Document: "Response to Comments to NJDEP Comments on Final Remedial Investigation Report for FTMM-18 dated October 2015 (and Landfill Boundary Refinement for FTMM-18 only dated January 2016)"

SUBJECT: *Final Remedial Investigation Report for FTMM-18 dated October 2015 (& Landfill Boundary Refinement for FTMM-18 only dated January 2016)*
Fort Monmouth, Oceanport, New Jersey
PIG000000032

Figure H1 - FTMM-18 Landfill Boundary Refinement and Methane Gas Survey Results

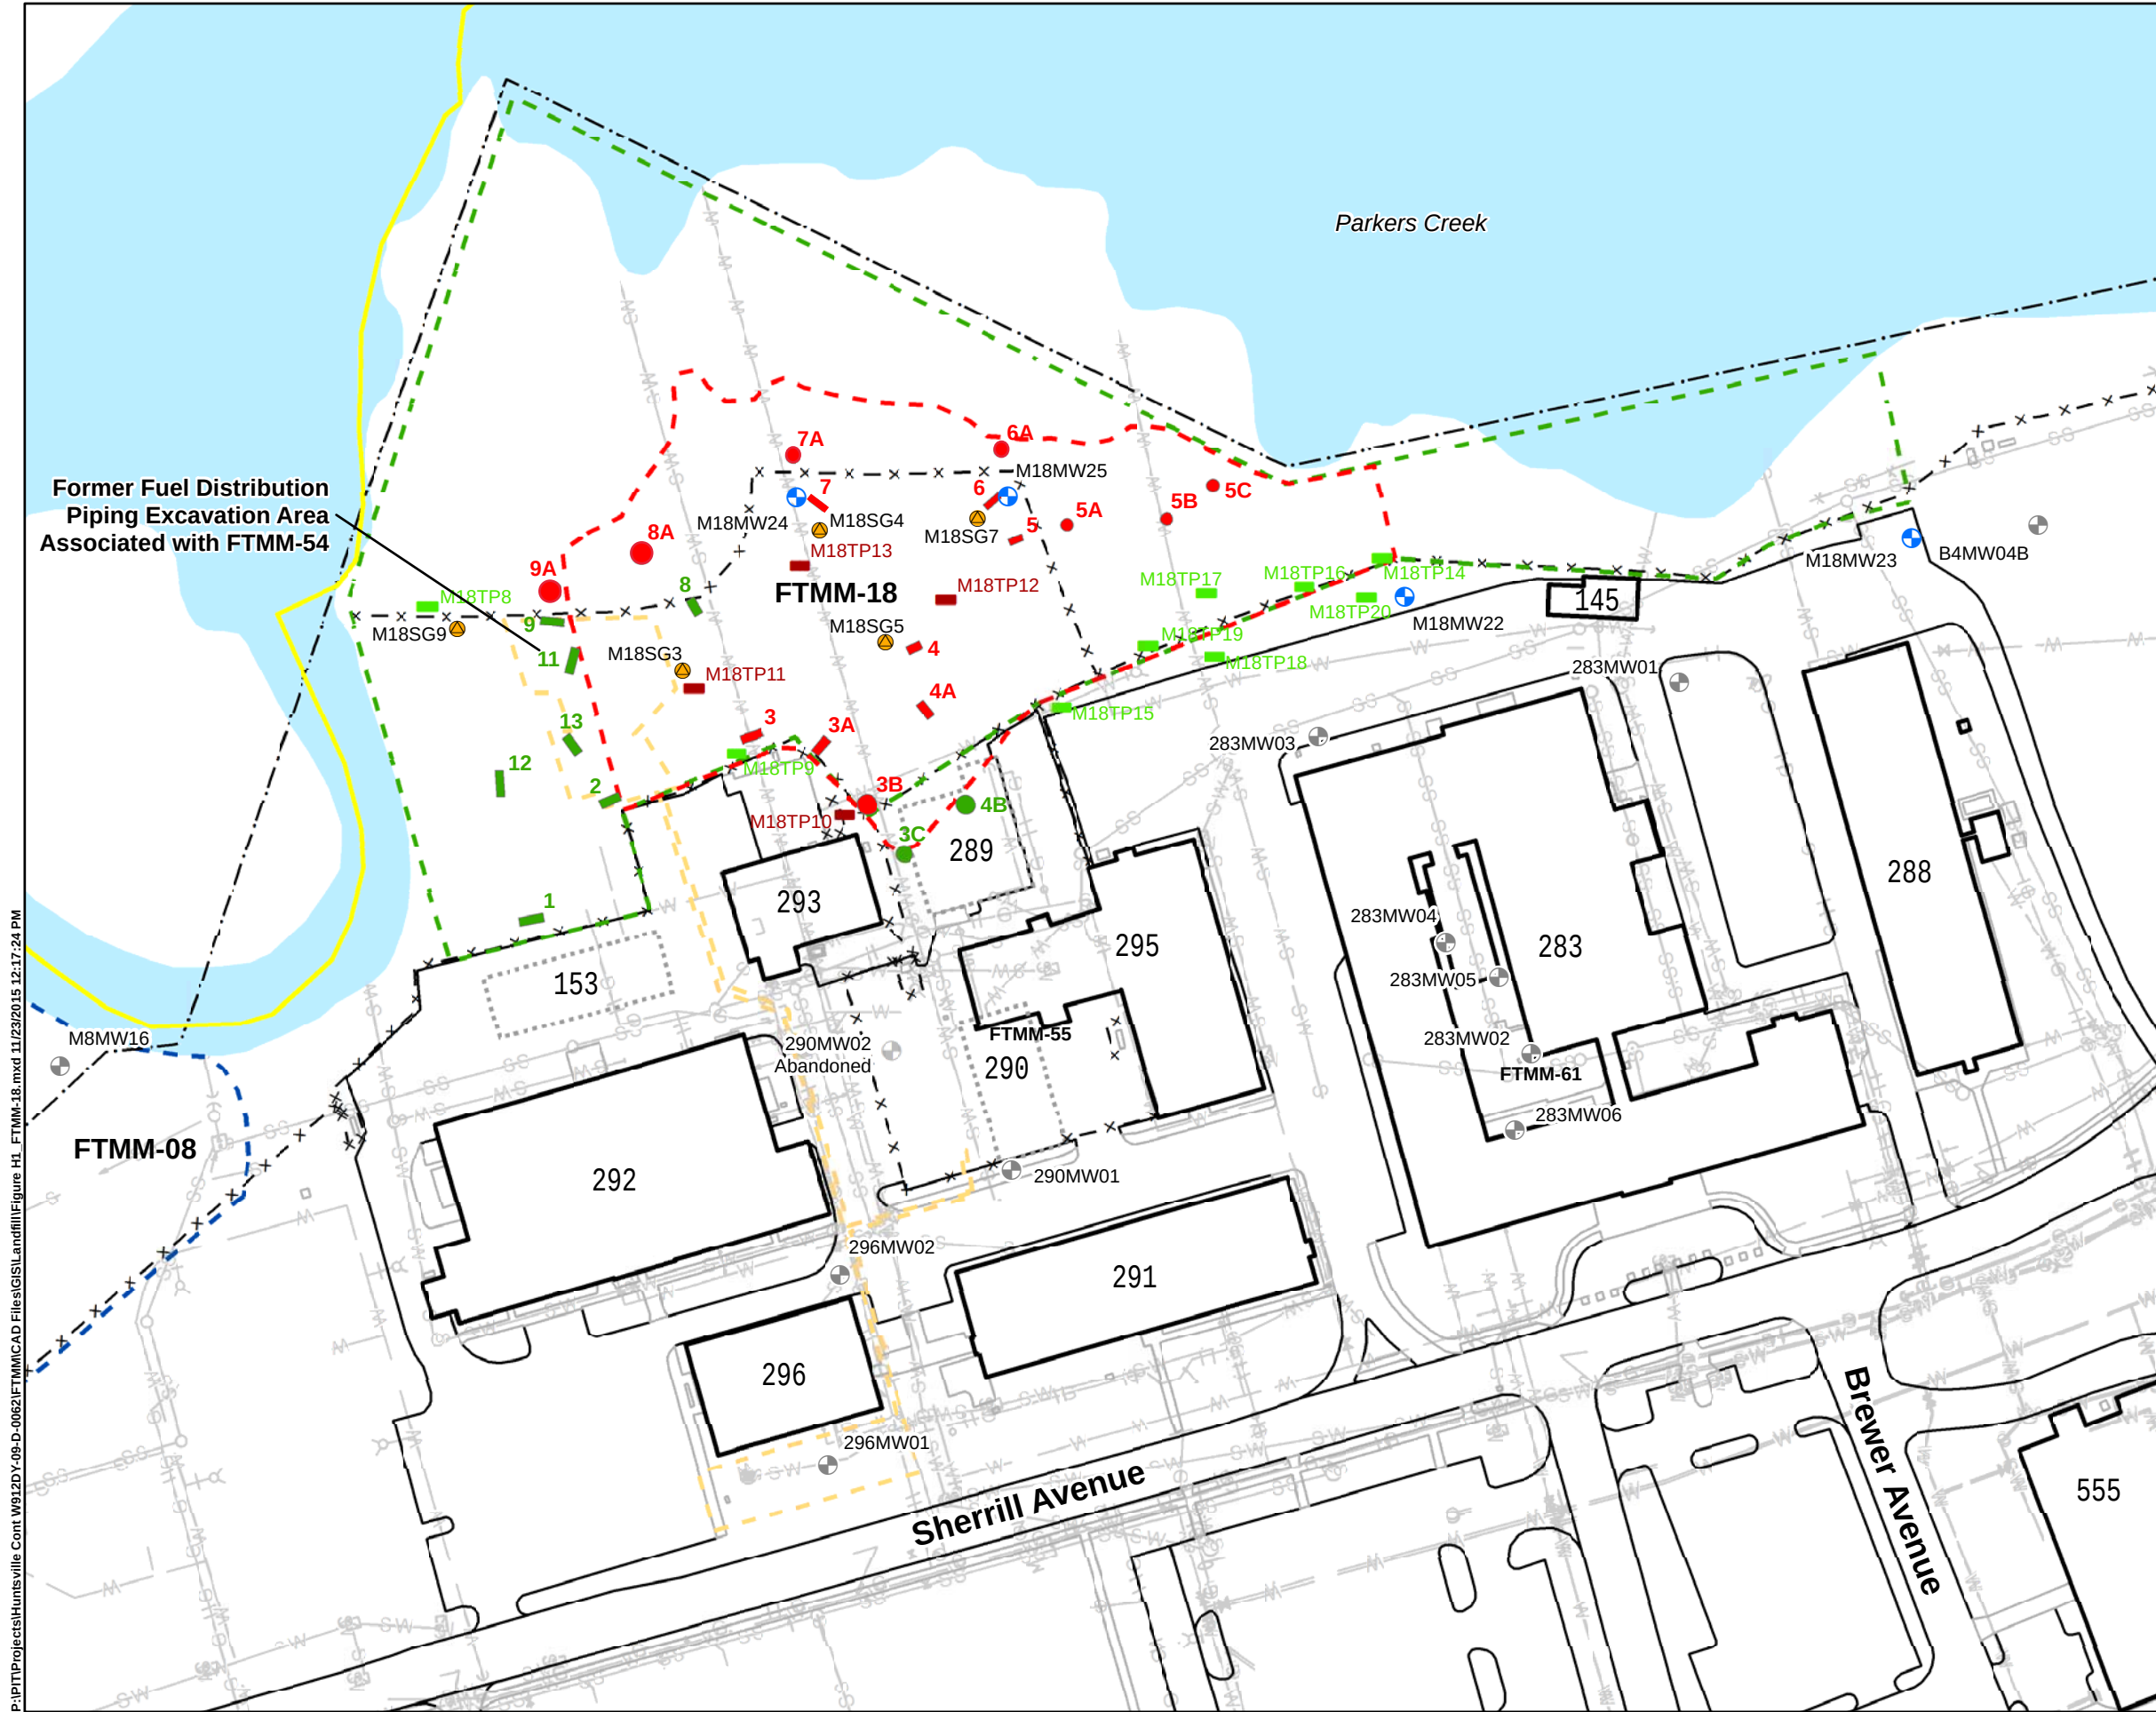
B. COMMENT: *Based upon reviews of the historic aerials, historic sampling locations and analytical findings, as well as test pit and boring locations and findings, the boundary as noted in Figure H1 of the January 2016 Landfill Boundary Refinement and Methane Gas Survey Report for Nine Landfills appears to adequately encompass the extent of known contamination and landfilled material at FTMM-18, with the following exceptions.*

Although located within the 2015 Revised Boundary of the landfill, Figure H1 of the Landfill Boundary Refinement submittal represents boring and test pit locations 6A, 7, 7A, 8 and 8A as "solid waste not present". The logs for those test pits and borings, however, found in Appendix A1 Appendix A of the RIR, indicate landfill material was present (concrete and asphalt were encountered from 1-2' at location 6A; concrete, asphalt and scrap metal from 2-4' at location 7).

M18TP10, based upon the test pit field log found in the Landfill Boundary Refinement submittal which references waste material including ash, coal and asphalt from 1-4', is shown on Figure H1 of the Landfill Boundary Refinement submittal as lying beyond the landfill boundary. Please explain why the boundary should not be expanded to include this area.

Two issues are noted with test pit M18TP14. The field log for test pit M18TP14 (and M28TP16 as well) indicates "no waste", however, the log references minimum or surface debris including glass and plastic bottles, and lumber. As has been discussed, the Department does not agree "minimum debris" exempts an area from consideration as landfill. M18TP14 and M18TP16 are

(marginally) located within the boundary as noted in Figure H1, however, any such debris located beyond the noted "boundary " must also be addressed either via extension of the engineering controls (cap) to those areas, or by incorporating the material into that area to be capped (e.g moving the material back into that area to be capped). Additionally, the log for M18TP14 includes a location sketch which appears to indicate MW25 is in the immediate area, rather than M1 8MW22. Please clarify.

B. RESPONSE: FTMM disagrees with NJDEP on their assessment of M18TP10, M18TP14, and M18TP16 and maintains that debris of a scattered nature and or *de minimus* quantity does not constitute a landfill. The solid waste regulations (N.J.A.C. 7:26-1.4) define a landfill as a solid waste facility or sanitary landfill, at which solid waste is deposited on or into the land as fill for the purpose of permanent disposal or storage for a period of time exceeding six months. As the contents of the test pits demonstrate, FTMM-18 contains primarily construction and demolition debris and does not constitute a landfill under the solid waste regulations definition. It is generally recognized that scattered debris may exist outside the limits of a consolidated landfill as such we made a judgment for FTMM-18 on a case-by-case basis that some debris (of a scattered nature and *de minimus*) in selected test pits did not constitute a landfill, which we believe is reasonable and appropriate given the wide variety of activities at FTMM over many decades. However, we believe the steps outlined below represent a reasonable compromise to achieve the project goals.

Figure H1 of the January 2016 Landfill Boundary Refinement Report has been revised to change borings 6A, 7, 7A, 8 and 8A from green indicating that "landfill solid waste not present" to red indicating that "landfill solid waste present". As these borings are within the October 2015 RIR, no revisions will be made to the landfill boundary.

At M18TP10, relocation of the debris material to within the landfill boundary is proposed to include this material under the proposed engineering control landfill cap.

The surface debris described in test pits M18TP14 and M18TP16 was observed at the ground surface and not within the actual test pits. During landfill cap construction, surface debris will be removed and placed under the landfill cover. Since no debris was observed at these two test pit locations below the ground surface, test pits M18TP14 and M18TP16 are correctly described as containing "no waste." The landfill boundary will not be revised in this area.

The log for M18TP14 incorrectly references M18MW22 as MW25, however, the rest of the location sketch correctly depicts the location of M18TP14 in relation to other site features. The corrected test pit log is attached. The location of M18TP14 is correctly depicted on the test pit log for M18TP16; on that test pit log location sketch, M18TP14 is shown 47.5 feet east of M18TP16.
